HL-120
DL-96
EL-47
FL-41

SERVICE LETTER

AVAILABILITY OF IMPROVED SPACERS TO BE USED ON THE SHOCK-MOUNTED SKID TUBE POSITION LIGHT ASSEMBLIES

Figure 1. Skid Tube Position Light Assembly

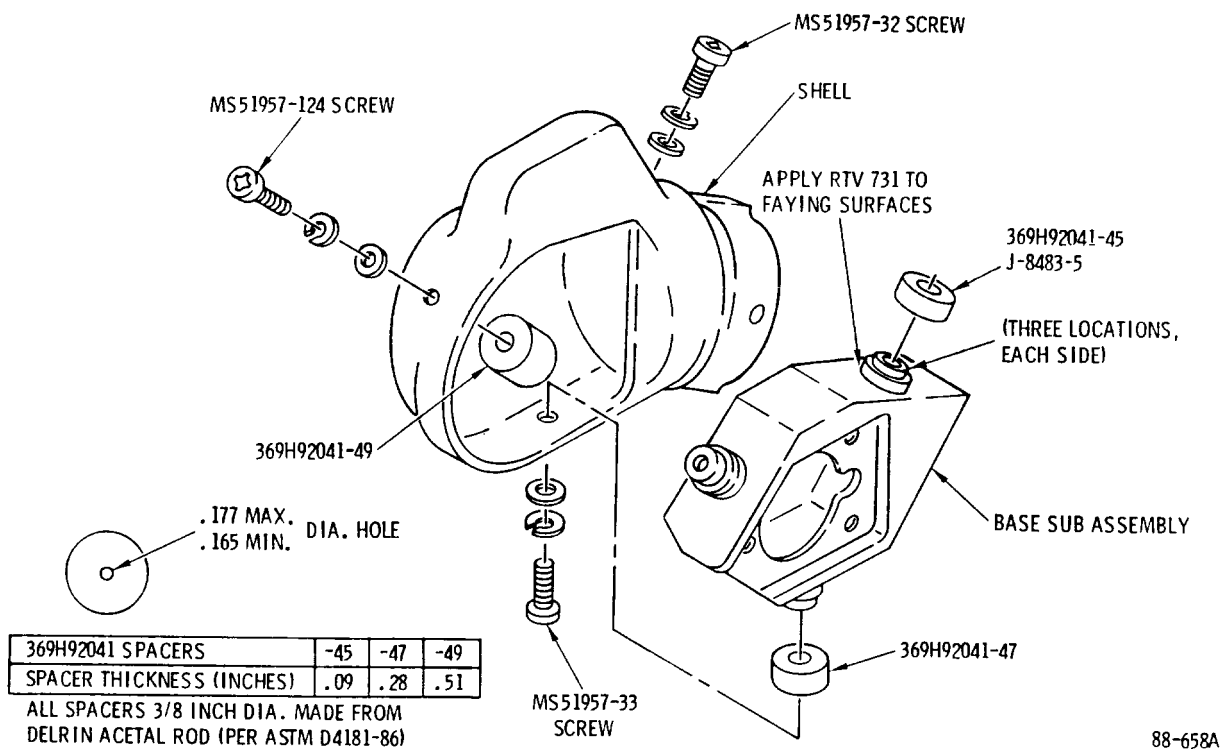
MDHC has received reports that some Lord shock mounts on the skid-mounted position light assemblies have been tearing in service. MDHC has improved the design with a change in mounting hardware and mounting procedures. The following parts list and procedure provides operators with instructions to modify their light assemblies to the improved configuration.

- a. Remove the left and right hand base sub-assemblies by removing (3) screws and associated hardware (each side). Discard existing spacers and mounting screws.
- b. Bond the three J-8483-5 isolator mounts to their respective base sub-assemblies using RTV 731
- c. Reinstall base sub-assemblies using the spacers and screws called Out in Figure I and the above parts list. Offer associated hardware is shown in Figure 1 and called out in the applicable illustrated parts catalogs.
